**Re: Fern Bay Seaside Village**

As requested we have reviewed Coastal Zone Management aspects of the proposed additional stages to Fern Bay Seaside Village in regard to location of the 100 Year Hind Dune Hazard Line on the landward of the Stockton Bight mobile sand dune system and the 100 Year Coastal Hazard Line.

**Figure 4.2 – Extracted from  
AWACS 1992**

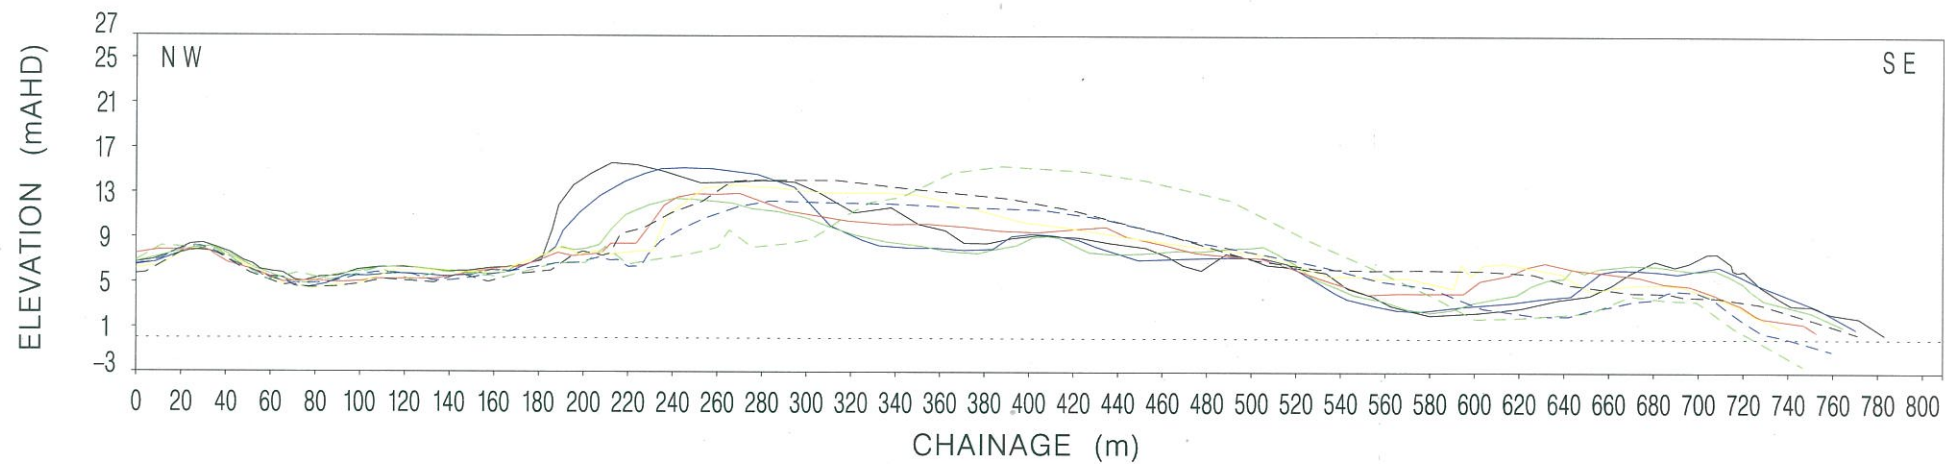
The results of the AWACS (1992) studies in regard to delineation of the Coastal Hazard Zone are summarised in **Table 1** and shown on Figure 4.2 (see **Attachment 1**) which has been extracted from the AWACS (1992) report.

Based on the above analysis it is considered that the 30 year and 100 year return period Coastal Hazard Lines would be seaward of the respective lines shown on Figure 4.2 of AWACS 1992 (see **Attachment 1**).

The results of the AWACS (1992) studies in regard to Hind Dune Hazard Zone Width are summarised in **Table 2** and shown Figure 4.2 (see **Attachment 1**) which has been extracted from the AWACS (1992) report.
